Subject: Duke Energy Corporation
McGuire Nuclear Station, Units 1 and 2
Docket Numbers 50-369 and 50-370
Catawba Nuclear Station, Units 1 and 2
Docket Numbers 50-413, 50-414
Proposed Technical Specifications and Bases
Amendment
2.0, Safety Limits; 3.3, Instrumentation; 3.4,
Reactor Coolant System; 5.6, Reporting
Requirements

Duke License Amendment Request of March 24, 2003

ATTACHMENT 1A

McGUIRE UNITS 1 AND 2 TECHNICAL SPECIFICATIONS
AND
TECHNICAL SPECIFICATION BASES

Figure 2.1.1-1

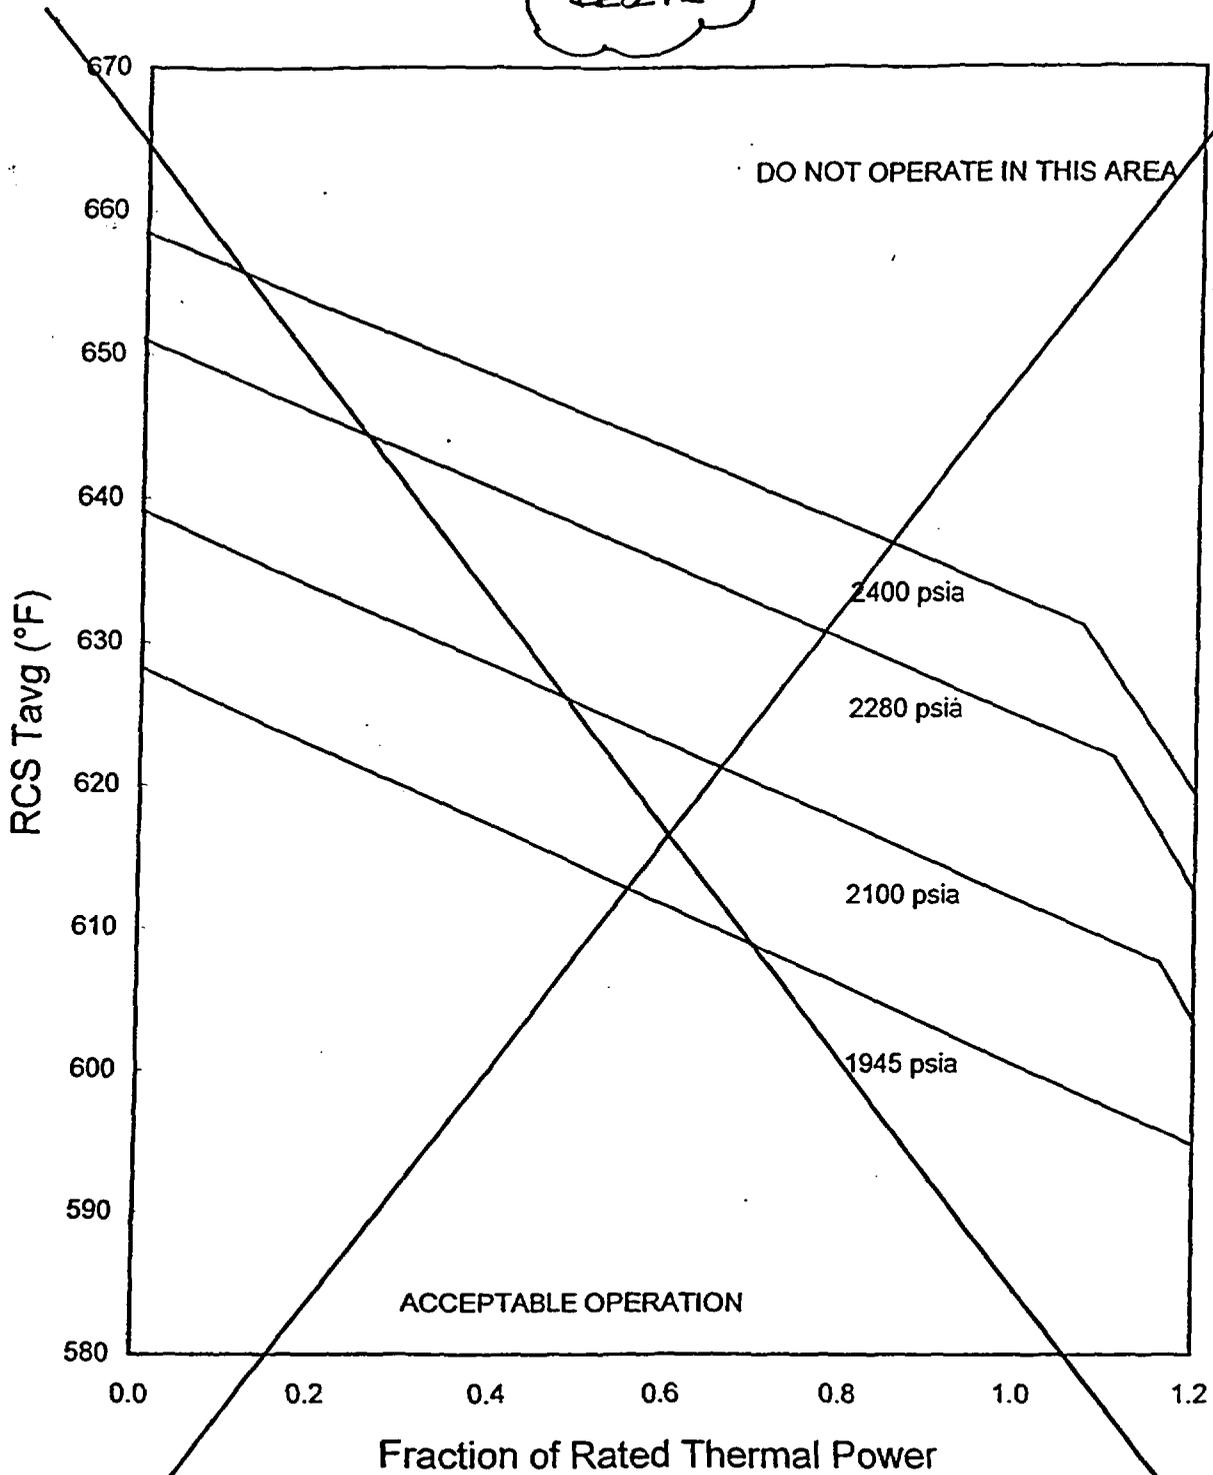
In MODES 1 and 2, the combination of THERMAL POWER, Reactor Coolant System (RCS) highest loop average temperature, and pressurizer pressure shall not exceed the SLs specified in Figure 2.1.1.1 for four loop operation.

DELETE

The proposed amendment also relocates TS Figure 2.1.1-1, "Reactor Core Safety Limits," to the COLRs, replacing it with more specific requirements regarding the safety limits (i.e. fuel DNB design basis and the fuel centerline melt design basis) conforming with WCAP-14483-A. As discussed in the Safety Evaluation Reports to WCAP-14483-A, it is necessary to relocate TS Figure 2.1.1-1 to the COLR since cycle-dependent changes to parameters upon which TS Figure 2.1.1-1 is based would require a license amendment request to revise the figure.

INSERT 1

the COLR for four loop operation; and the following SLs shall not be exceeded:

- 2.1.1.1 The departure from nucleate boiling ratio (DNBR) shall be maintained ≥ 1.14 for the WRB-2M CHF correlation.
- 2.1.1.2 The peak fuel centerline temperature shall be maintained < 5080 degrees F, decreasing 58 degrees F for every 10,000 MWd/mtU of fuel burnup.

Figure B 2.1.1-1

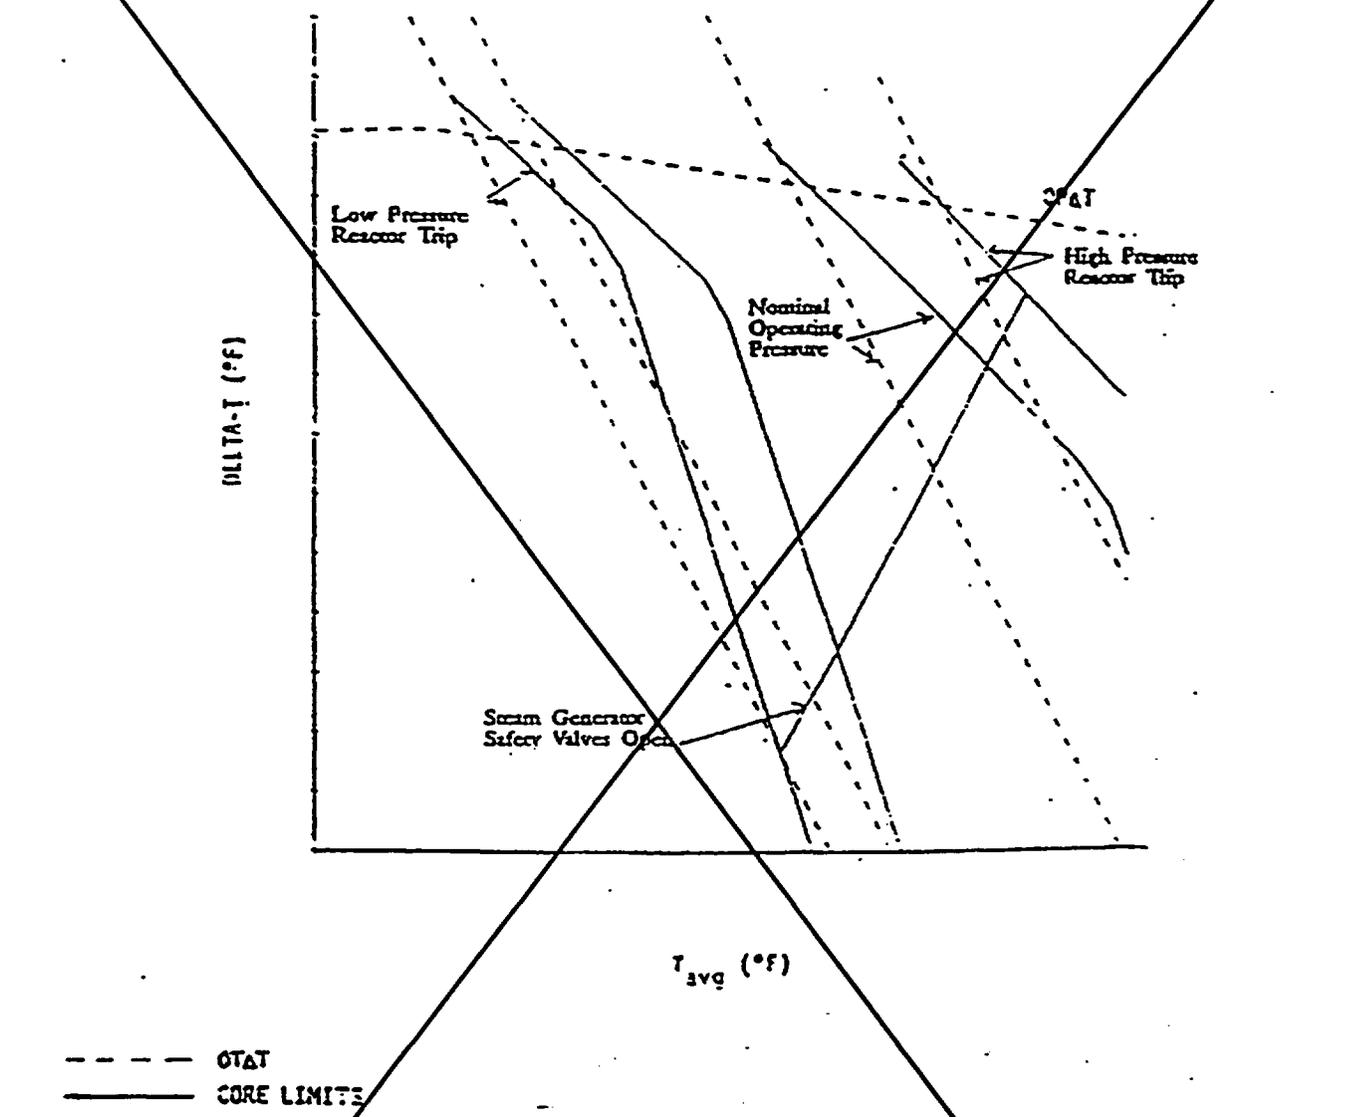
The curves provided in Figure B 2.1.1-1 show the loci of points of RCS Pressure, and average temperature for which the minimum DNBR is not less than the safety analyses limit, that fuel centerline temperature remains below melting, that the average enthalpy in the hot leg is less than or equal to the enthalpy of saturated liquid, and that the exit quality is within the limits defined by the DNBR correlation.

The curves in Figure 2.1.1-1 are based on a reference nuclear enthalpy rise hot channel factor (F_{DH}), a reference axial power shape ($F_z, x/L$), the approved CHF correlation and the Technical Specification minimum flow rate. Therefore, these curves provide limits for which the analyses analyzed at the above reference values will be bounded. The curves in Figure B 2.1.1-1 illustrate the various RPS functions that are designed to prevent the unit from reaching the limit.

DELETE

FIGURE

THE COLR SHOWS

Figure 2.1.1-1
Reactor Core Safety Limits
Four Loops in Operation

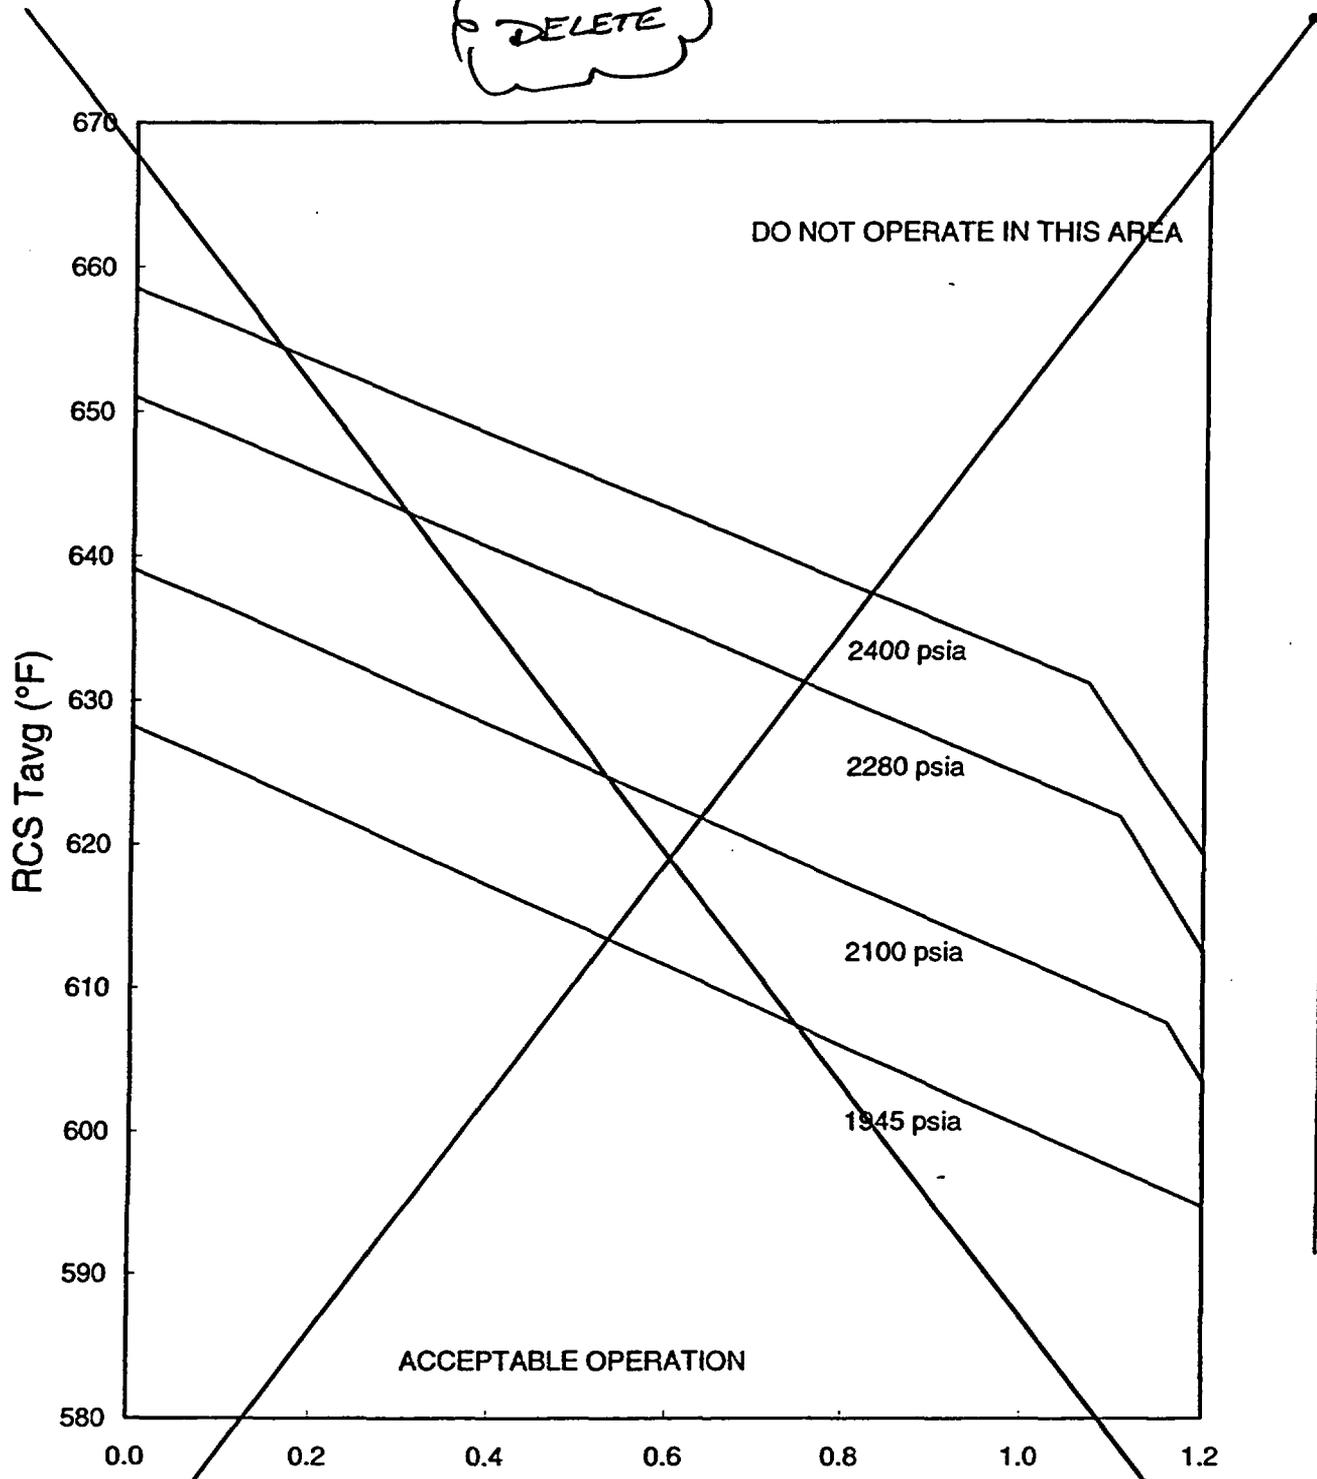
In MODES 1 and 2, the combination of THERMAL POWER, Reactor Coolant System (RCS) highest loop average temperature, and pressurizer pressure shall not exceed the SLs specified in Figure 2.1.1-1 for four loop operation.

DELETE

the COLR for four loop operation; and the following SLs shall not be exceeded:

- 2.1.1.1 The departure from nucleate boiling ratio (DNBR) shall be maintained ≥ 1.14 for the WRB-2M CHF correlation.
- 2.1.1.2 The peak fuel centerline temperature shall be maintained < 5080 degrees F, decreasing 58 degrees F for every 10,000 MWd/mtU of fuel burnup.

Figure B 2.1.1-1

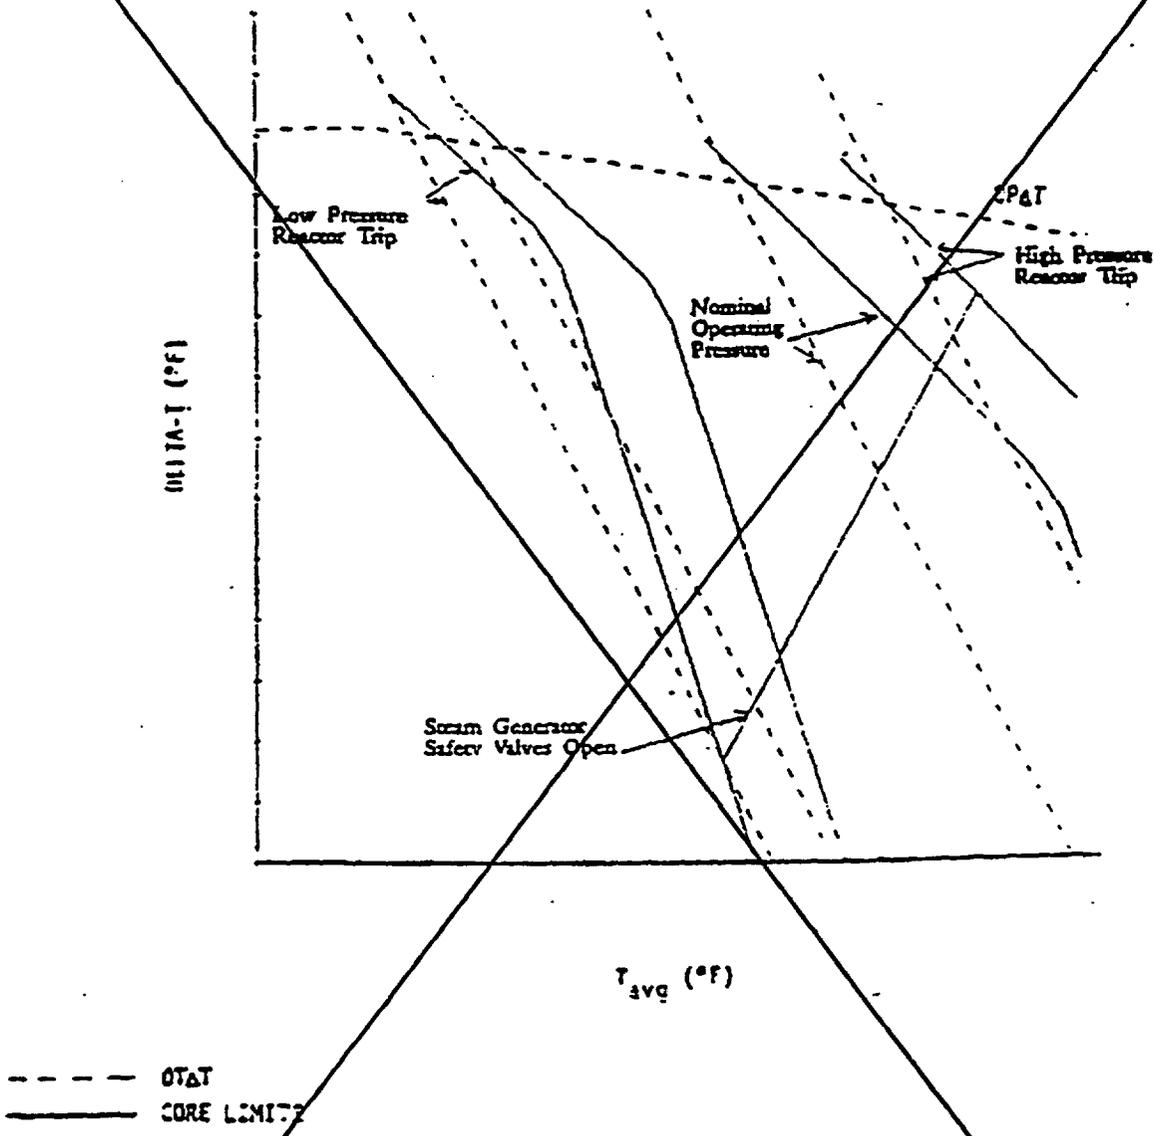
The curves provided in Figure B.2.1.1-1 show the loci of points of ~~DNBR~~, RCS Pressure, and average temperature for which the minimum DNBR is not less than the safety analyses limit, that fuel centerline temperature remains below melting, that the average enthalpy in the hot leg is less than or equal to the enthalpy of saturated liquid, and that the exit quality is within the limits defined by the DNBR correlation.

~~The curves in Figure 2.1.1/1 are based on a reference nuclear enthalpy rise hot channel factor (F_{CH}), a reference axial power shape ($F_z, x/L$), the approved CHF correlation and the Technical Specification minimum flow rate. Therefore, these curves provide limits for which the analyses analyzed at the above reference values will be bounded. The curves in Figure B.2.1.1-1 illustrate the various RPS functions that are designed to prevent the unit from reaching the limit.~~

DELETE

FIGURE THE COLOR SHOWS
